City of Cody Planning, Zoning and Adjustment Board

Thursday, May 21, 2026-12:00 PM

CITY OF CODY PLANNING, ZONING AND ADJUSTMENT BOARD STAFF REPORT

MEETING DATE:	MAY 21, 2026	TYPE OF ACTION NEEDED	
AGENDA ITEM:		P&Z BOARD APPROVAL:	X
SUBJECT:	DOWNTOWN ARCHITECTURAL REVIEW: ADDITION OF LIGHTNING PROTECTION SYSTEM AT 1234 SHERIDAN AVE. SPR2026-0039	RECOMMENDATION TO COUNCIL:	
PREPARED BY:	JENNY CRAMER, CITY PLANNER	DISCUSSION ONLY:

1
NE 3D VIEW - LIGHTNING
SCALE:

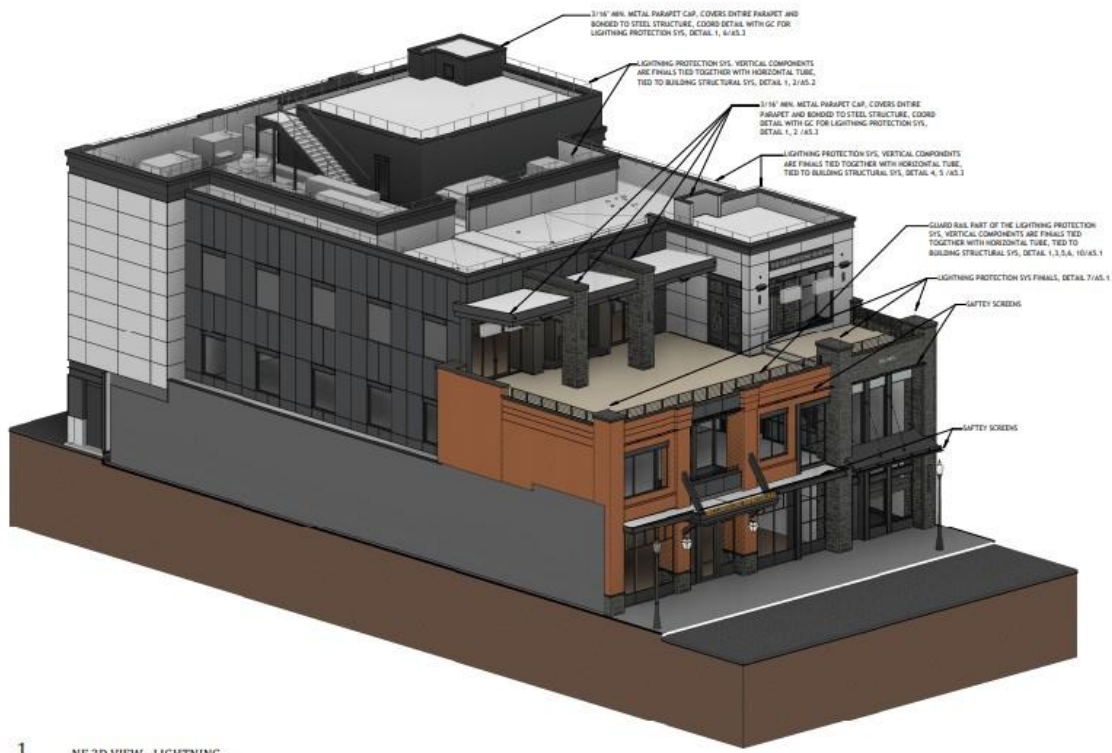
The appearance of the vertical finials and tube is that of a railing and the metal parapet caps will not change the architectural characteristics of the building. The safety screens are minimal in appearance on the front of the building. This particular LPS design is intended to match the building aesthetics and not be distinguishable or identifiable in appearance as a lightning protection system.

The lightning protection system components do not exceed the highest point of the building, as approved in the building plans.

1. Additional plan review and approval is required by the building department prior to commencement of lightning protection system construction and installation.

Rendering with balcony and sign revisions 2026

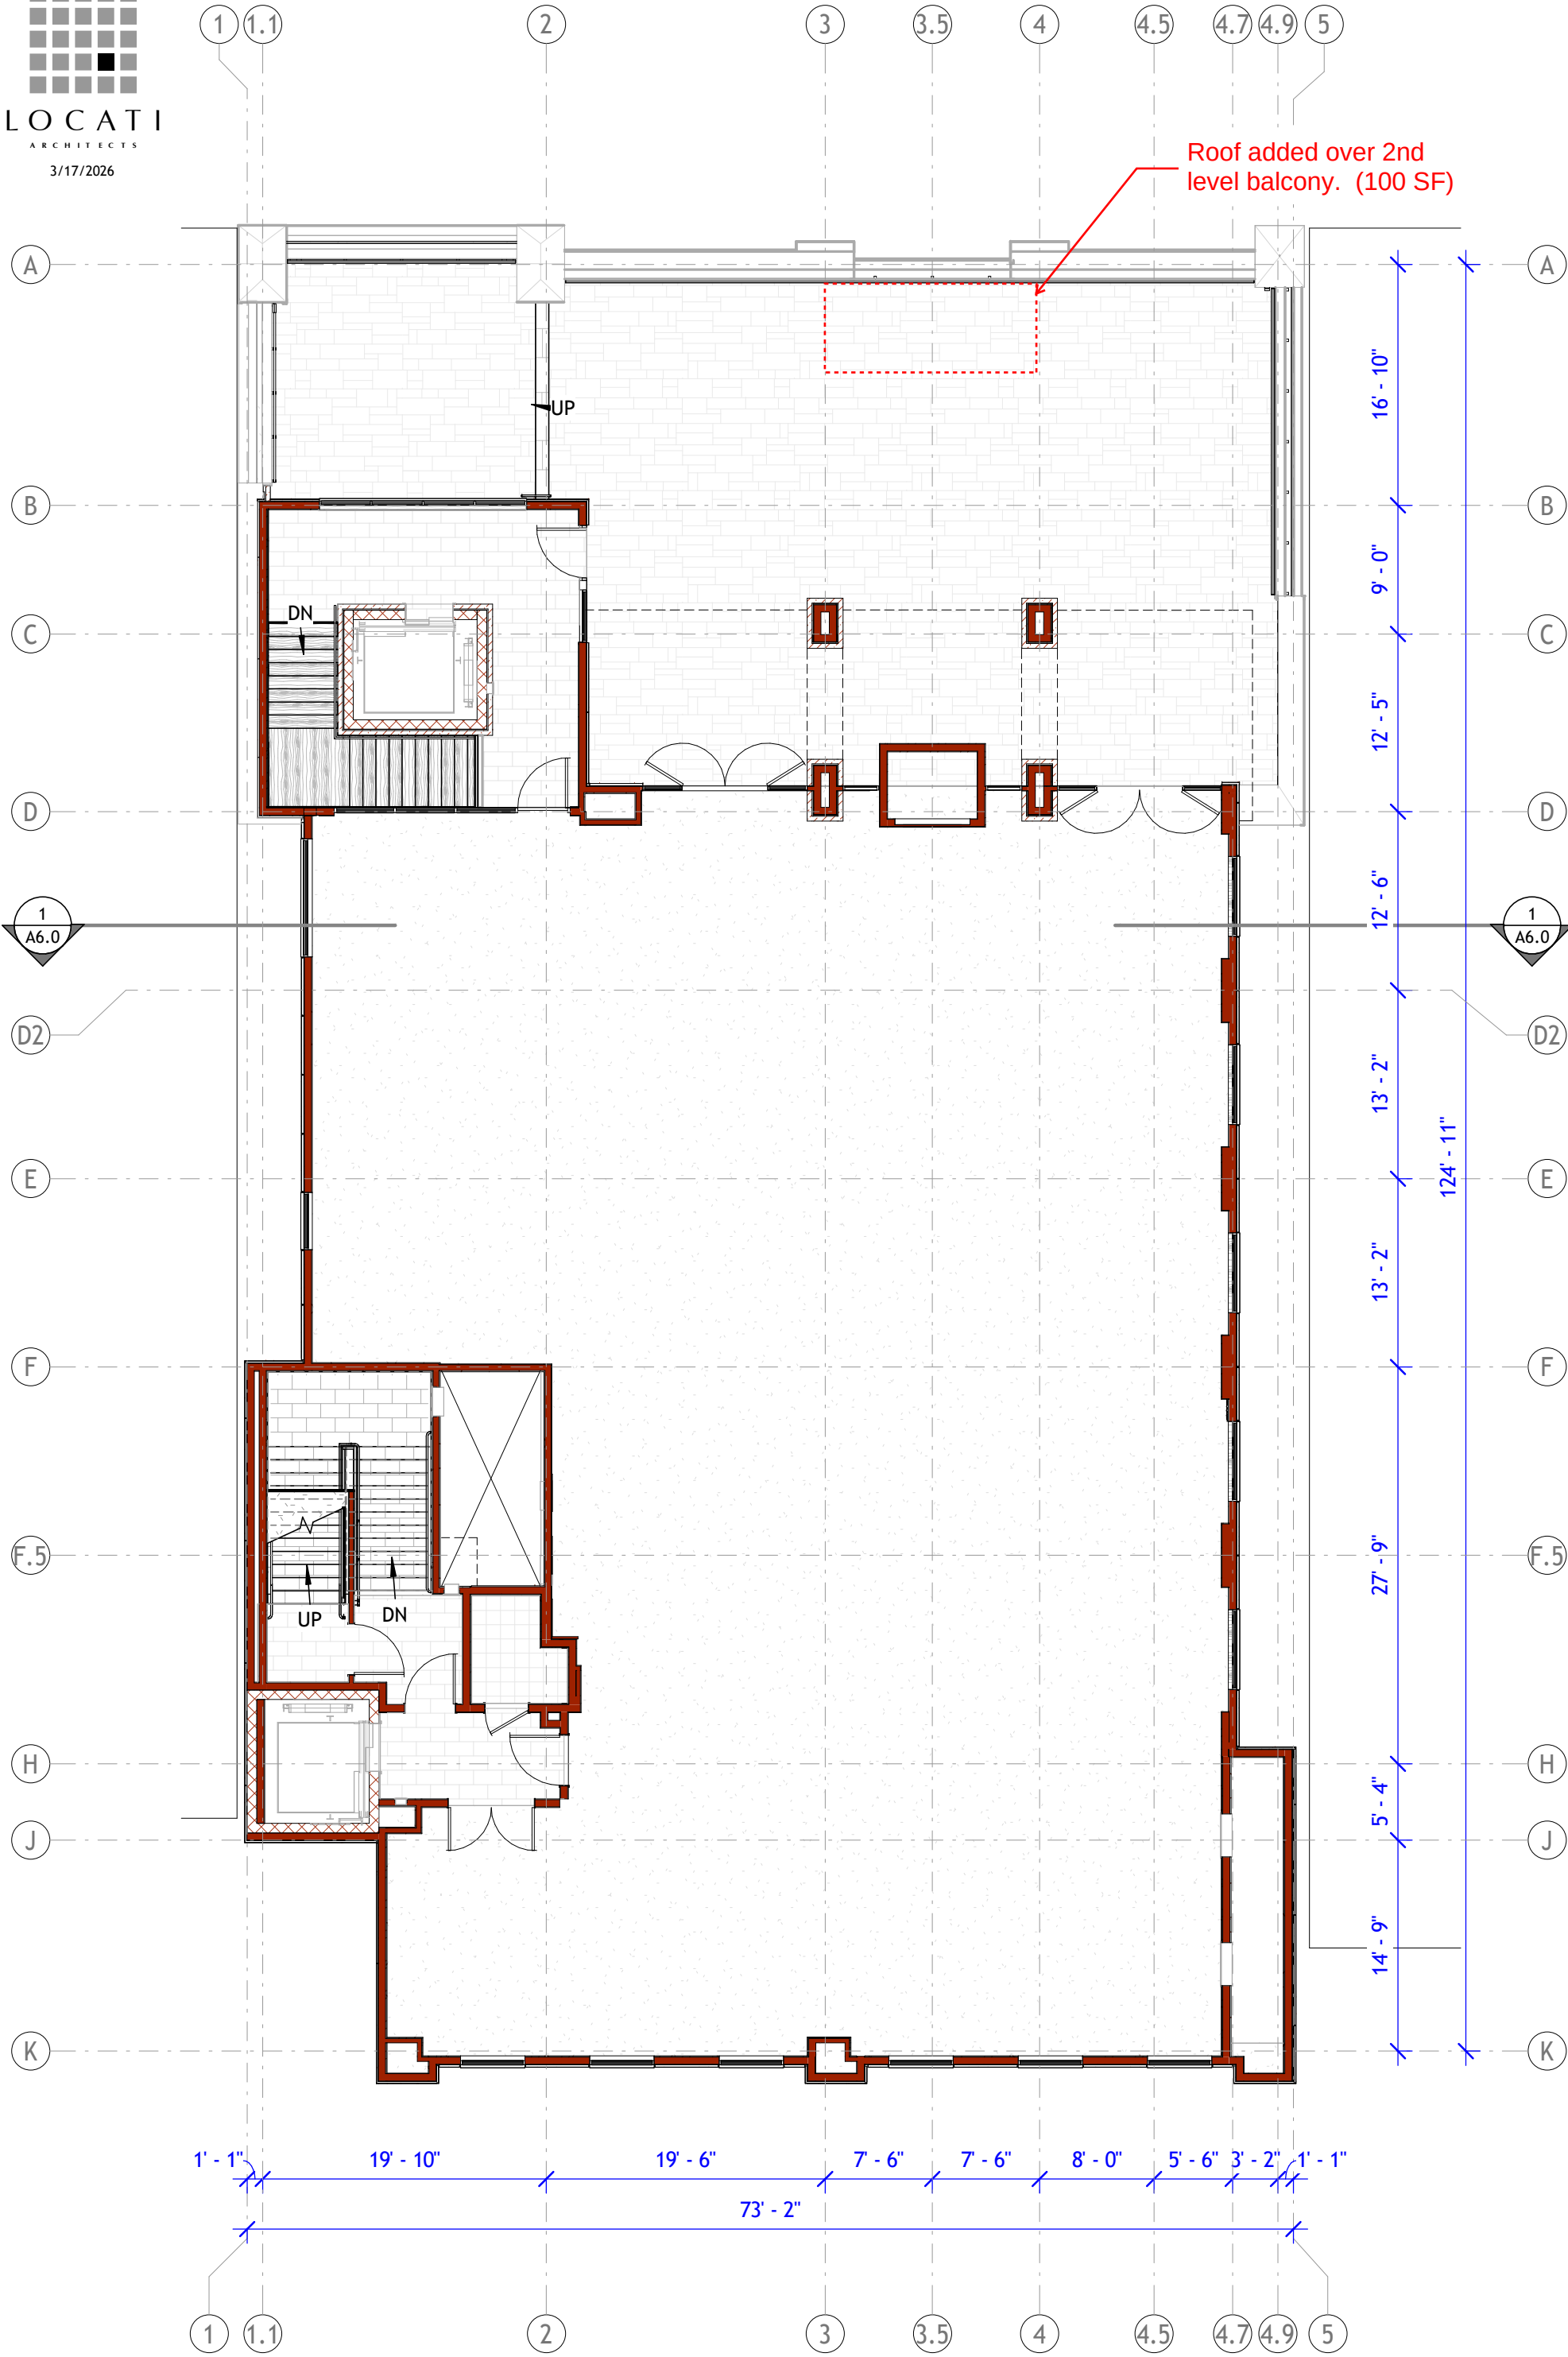
The proposed modifications do not appear to change the overall appearance of the building. The balcony area to be extended (roof over 2nd level balcony) was previously designed to be inset from the rest of this section. The colors and materials remain the same. The sign design, material and colors remain the same, only the wording of the building name is proposed to change.

Signage was approved as part of the original site plan review for the development. The applicant is proposing to change the attached wall sign on the third floor from "The Pavilion" to "The Yellowstone Building". The size of the sign will increase to 24.2 sq-ft from 17.5 sq-ft., as it will be longer to accommodate more letters. All other elements of the design remain the same. The slight increase in sign size remains compliant with sign size limits in the sign district (110.88 sq-ft is allowed for wall signage.)

1. Additional plan review and approval is required by the building department prior to commencement of construction and installation.

SITE /
LANDSCAPE PLAN

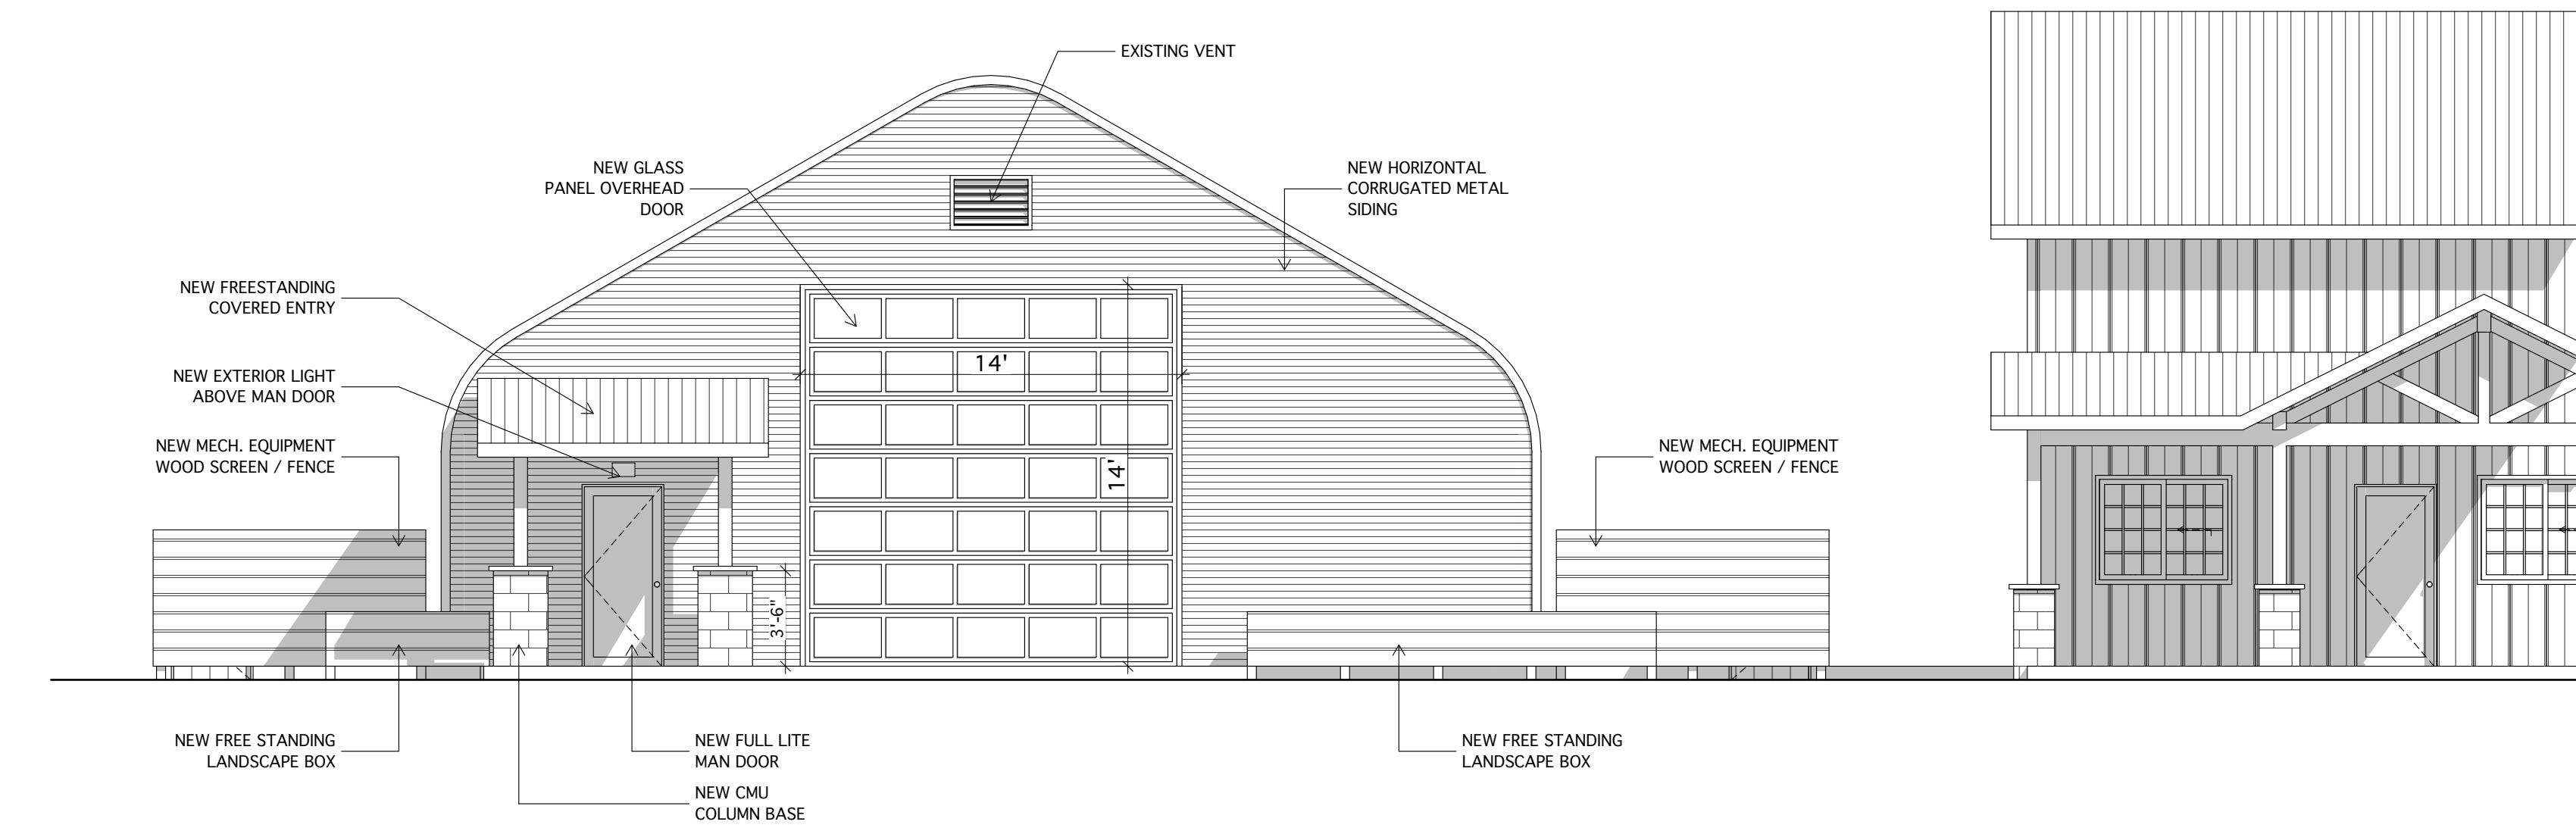
The site plan shows the existing parking spaces, one of which is designated as an ADA space on the north side of the existing structure. Six new parking spaces are shown on the west side of the property. The additional parking spaces are adequate to serve the new structure for storage or warehousing purposes.

A paved entrance/exit extending from the curb cut, to a point at least twenty-five feet (25') from the public street, measured along the direction of travel is required per Section 10-16-8-H-2. This is shown on the site plan.

Landscaping is proposed along the front corners of the building and along the east and west boundaries of the property, as shown on the provided plans. This is covered in more detail in the architectural and landscape review following this review.

Site drainage was reviewed and approved when the structure was put in place previously. The site plan includes the existing drainage retention basin. The structure

A snow storage area is designated on the site plan, in the southeast portion of the property.

The site plan includes a location for a dumpster at the southeast corner of the structure. The applicant will need to coordinate with the City Sanitation Department for placement.

1. A building permit must be obtained within three years or this authorization will expire.
2. A paved entrance/exit extending from the curb cut, to a point at least twenty-five feet (25') from the public street, measured along the direction of travel is required, prior to issuance of a final certificate of occupancy.
3. A change of use in the structure from private storage will require review by the community development department, building official and fire marshal for zoning, building code and fire protection compliance.

NORTH ELEVATION

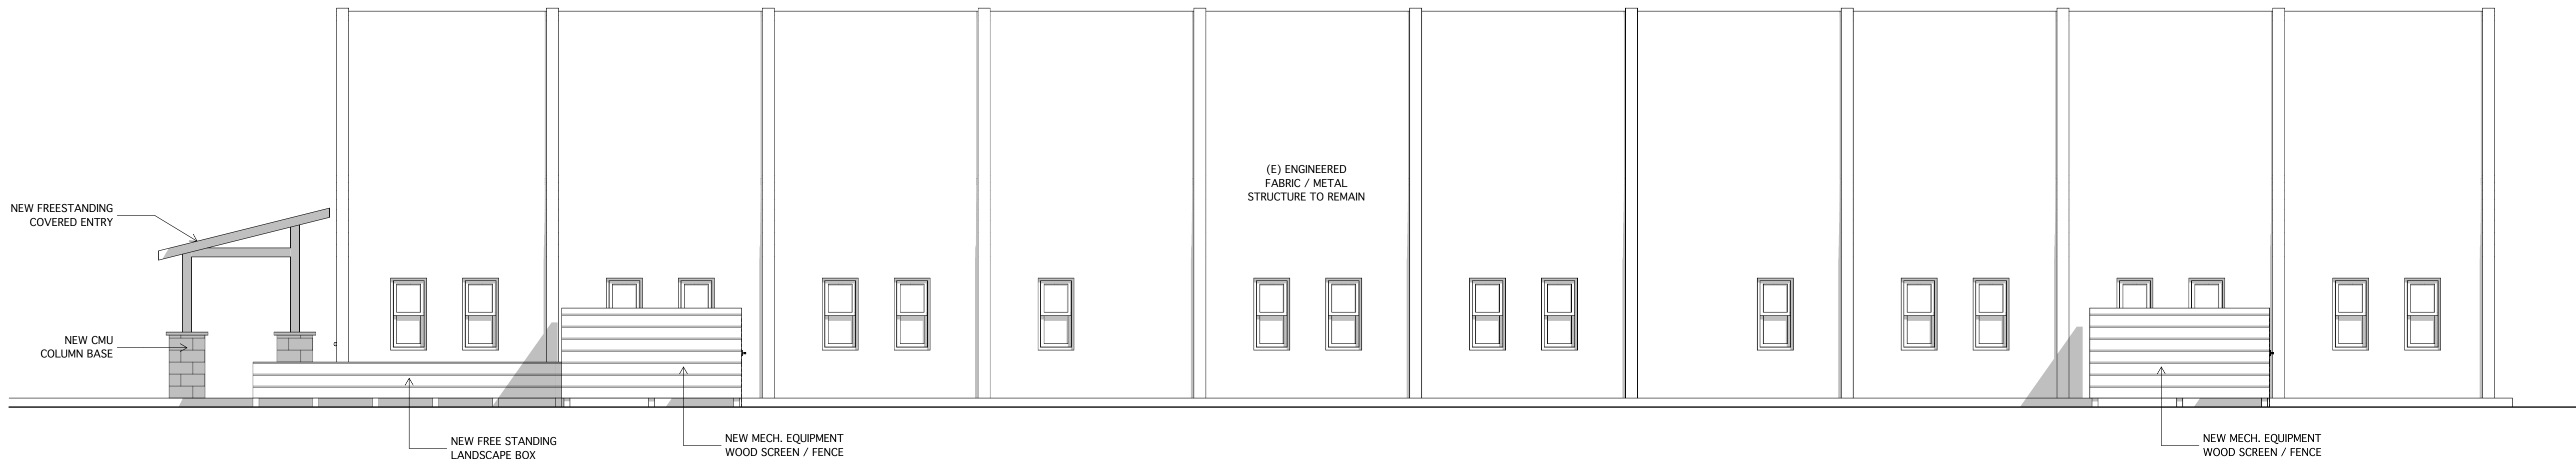
An exterior light is proposed and shown on the north elevation drawing, above the main door. The proposed specification sheet provided by the applicant indicates they will use the 3,000K CCT and 850 lumen settings of a WPX3 lumen light fixture. The fixture is downcast, shielded and will be located under a covered entry. A depiction of the fixture is shown to the right.

The building measures 40' by 120', and is 21'5" in overall height. The north perspective shown in the elevation drawing would face Big Horn Avenue.

A covered entrance, glass overhead door and landscaping enhance the appearance of the building.
